SITE INSTRUCTION

PROJECT: HAMPTON MANOR
25 BAKER HILL BLVD
STOUFFVILLE, ONTARIO

SITE INSTRUCTION: M-14

Purpose: To suit architecture suite layout changes.

TITLE 2ND FLOORS PLAN MECHANICAL			
PROJECT 25 BAKER HILL BLVD. ROYAL PINE HOMES			
STOUFFVILLE, ONTARIO PROPOSED RESIDENTIAL DEVELOPMENT			
DRAWN GC JUNE 2015	CHECKED ST 14-016	SCALE 1:100	DRAWING M-10 OF 42

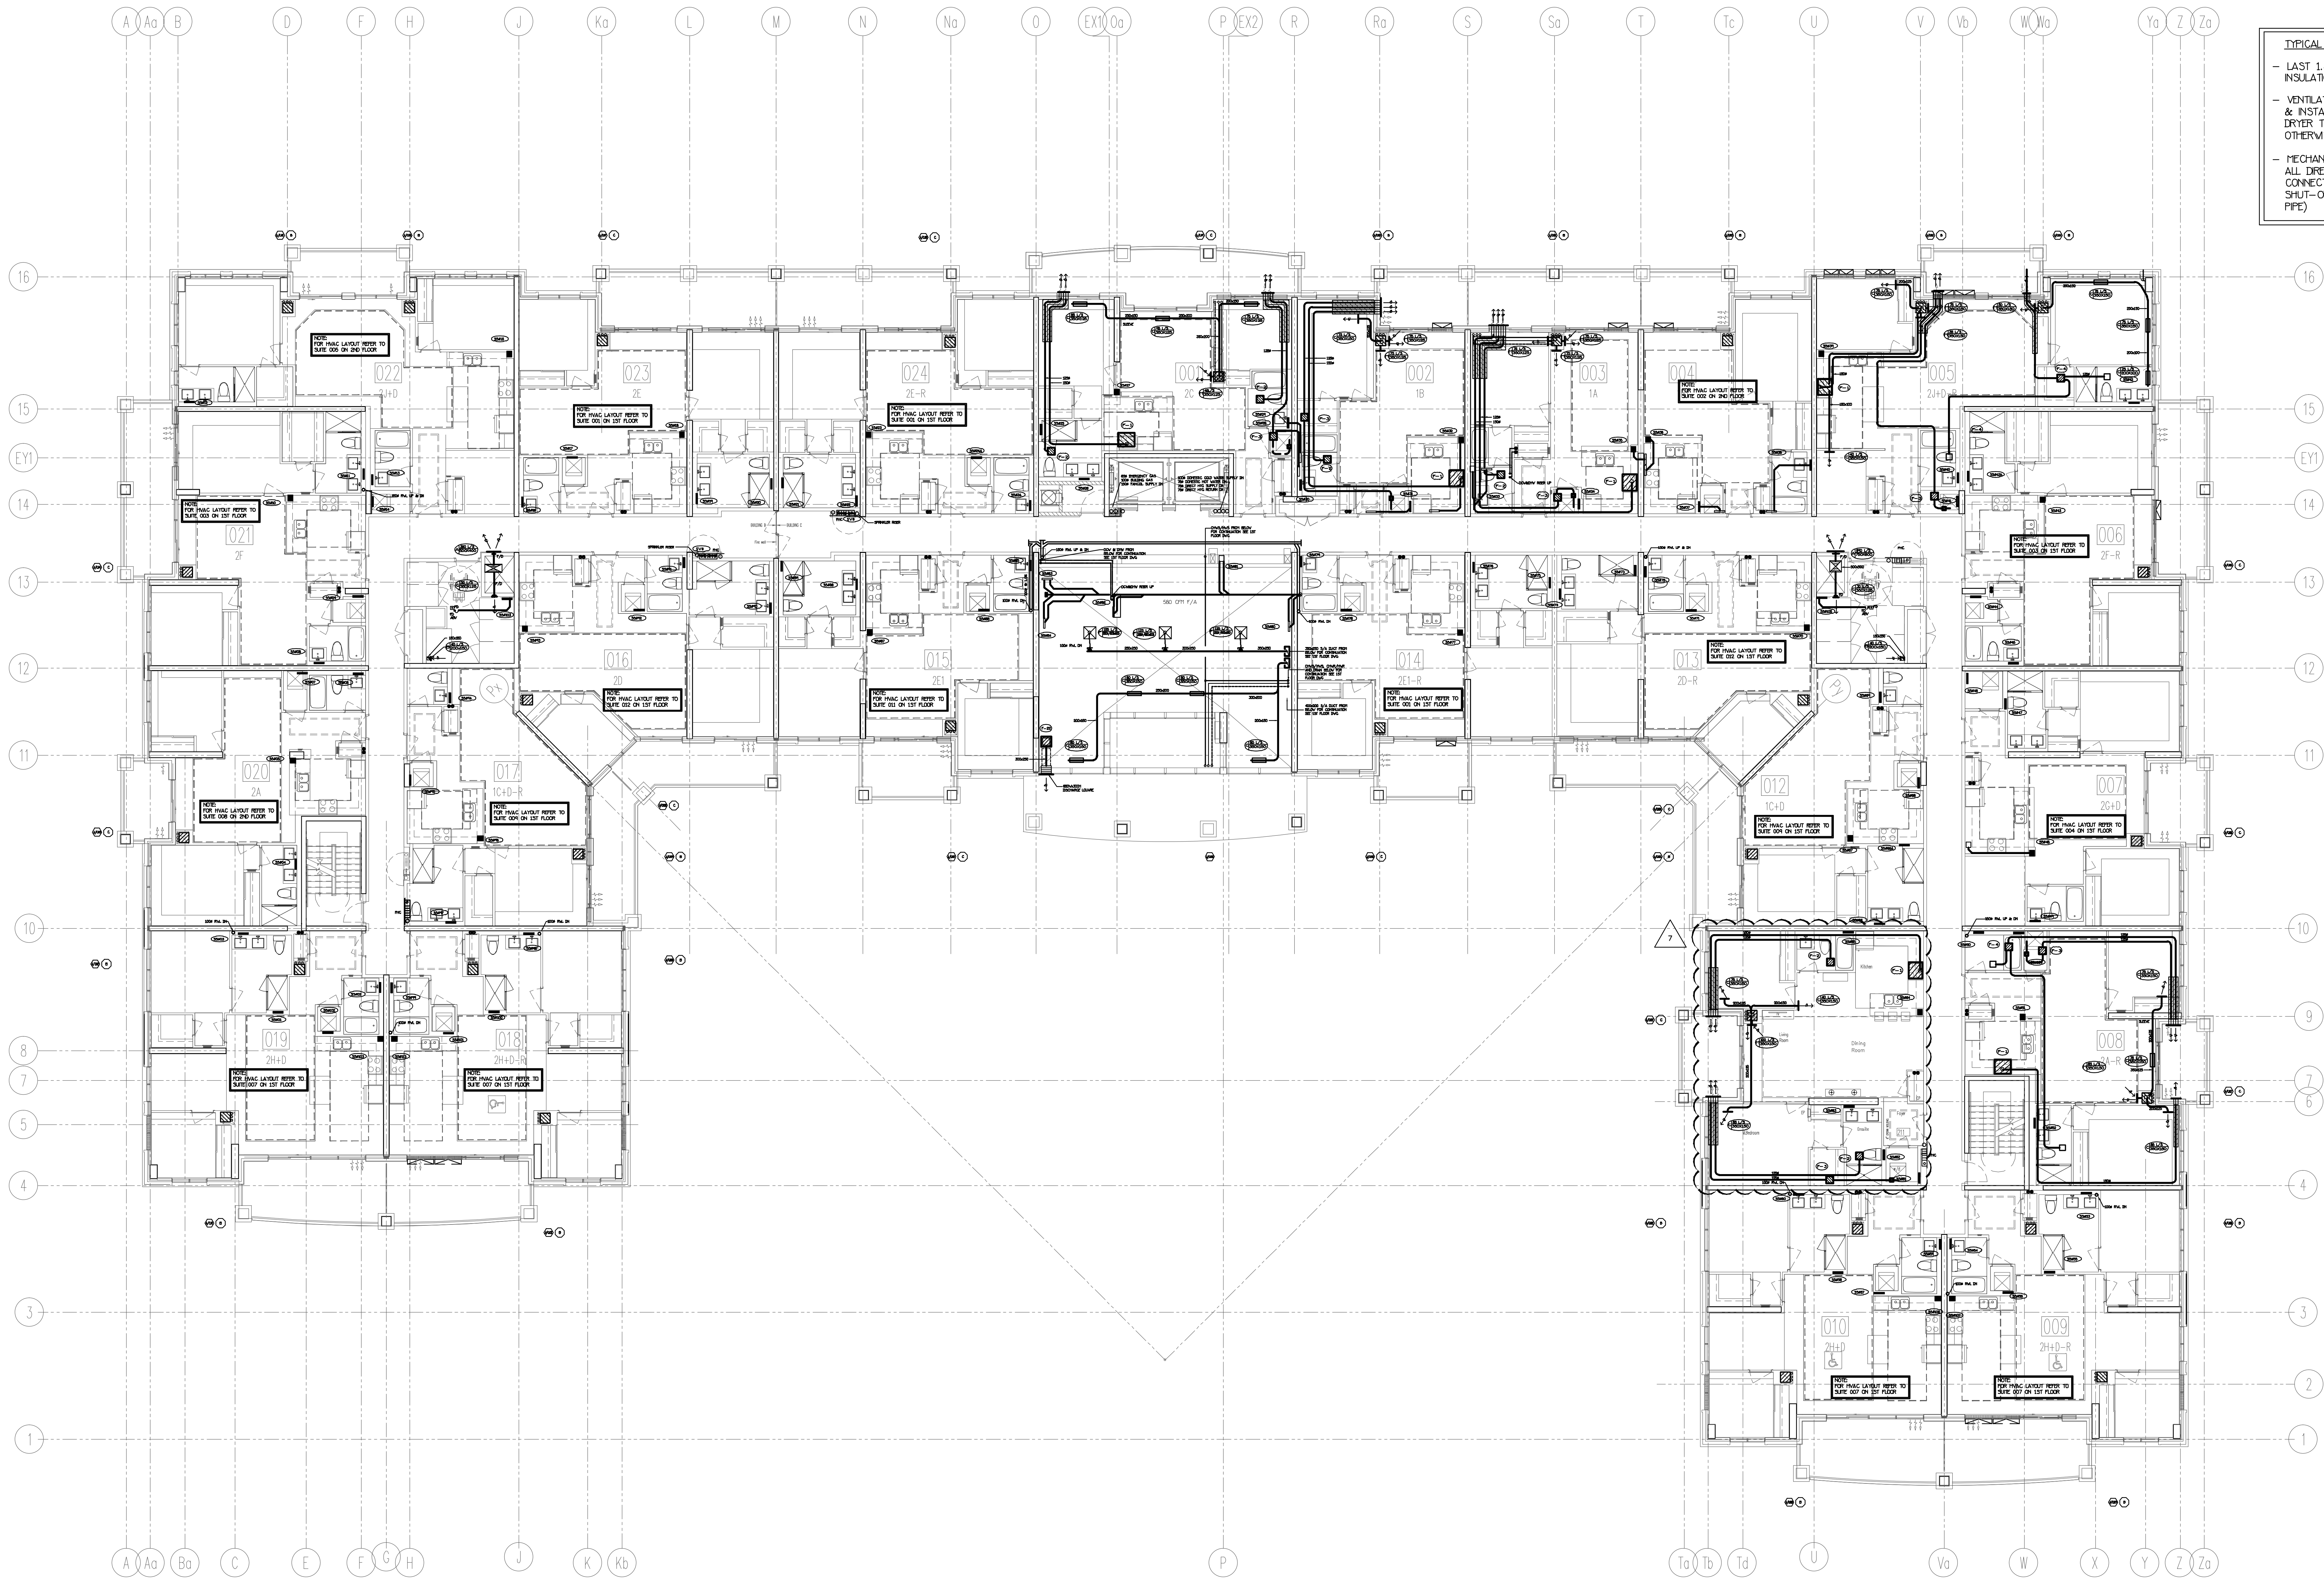
2.0 Reference Drawing M-10, M-14 (2nd Floor - Mechanical) Issued

2.1 Revised: Mechanical layout at suite 211.

TITLE PART 3RD AND 4TH FLOORS MECHANICAL			
PROJECT 25 BAKER HILL BLVD. ROYAL PINE HOMES			
STOUFFVILLE, ONTARIO PROPOSED RESIDENTIAL DEVELOPMENT			
DRAWN	GC	CHECKED	BT
DATE	JUNE 2015	PROJECT	14-016
		DRAWING	M-15
		OF	42

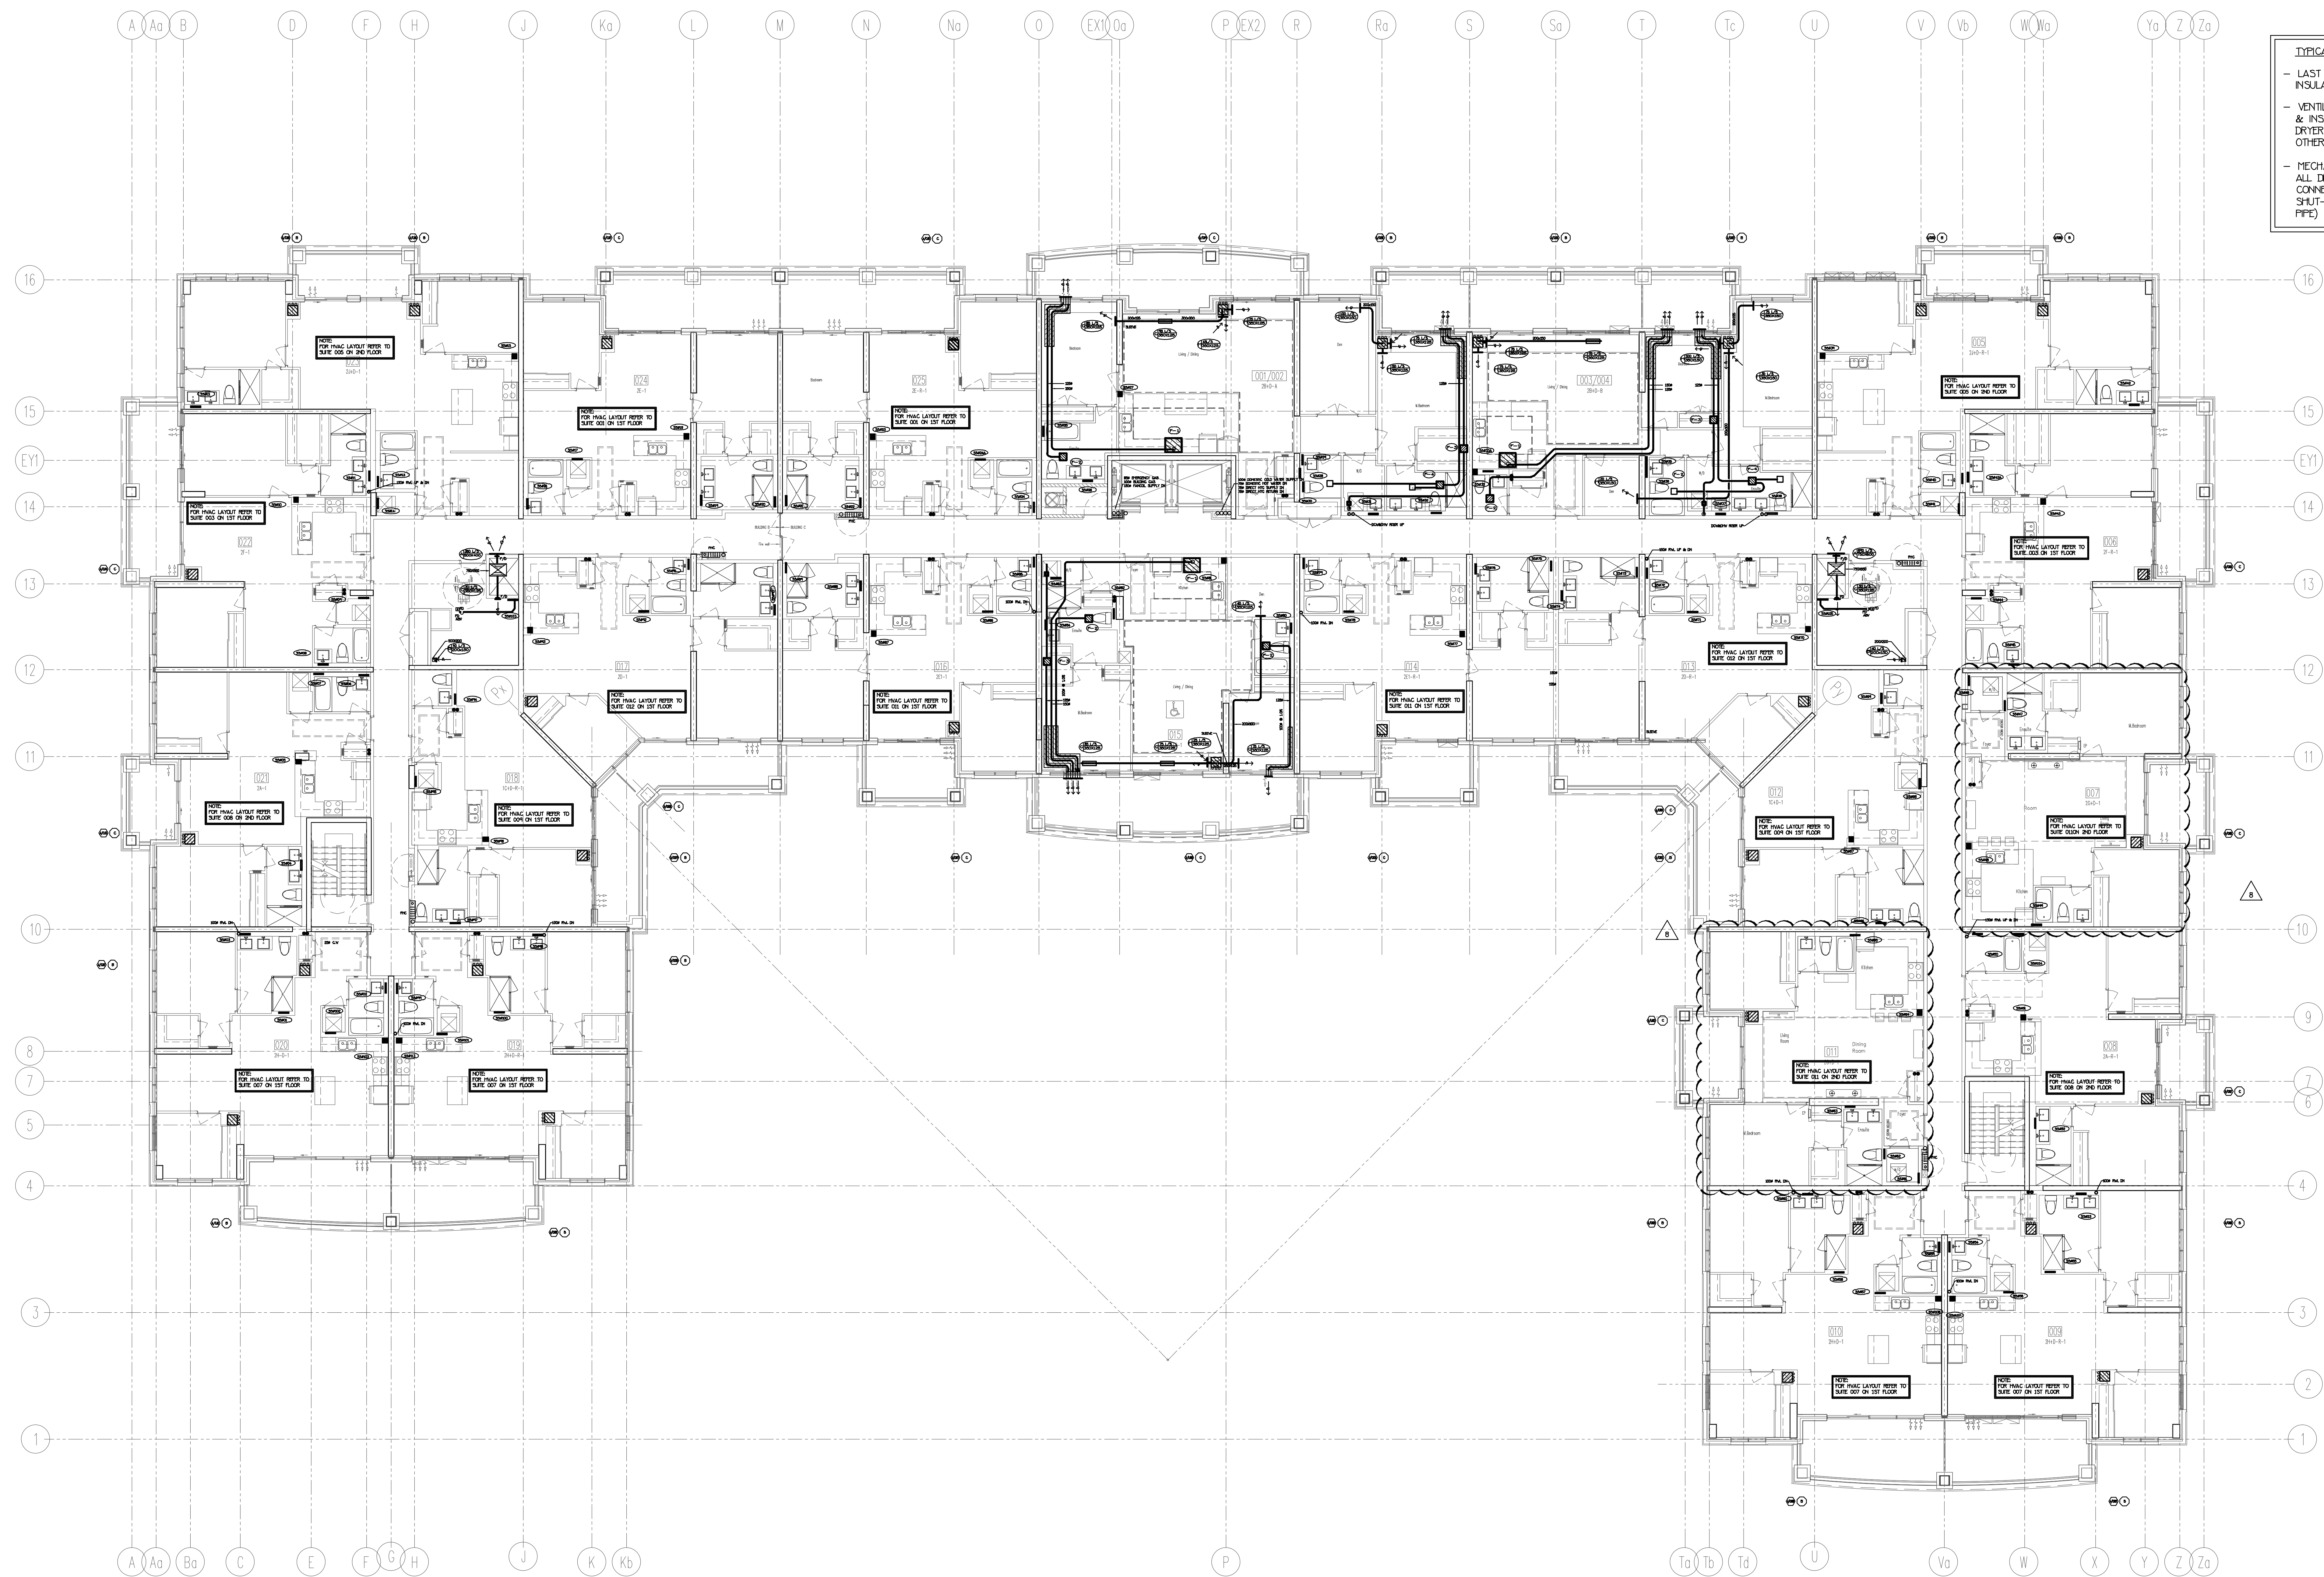
3.0 Reference Drawing M-15, M-18, M-19 (3rd, 4th Floor - Mechanical) Issued

3.1 Revised: Mechanical layout at suite 307, 311, 407, 411.
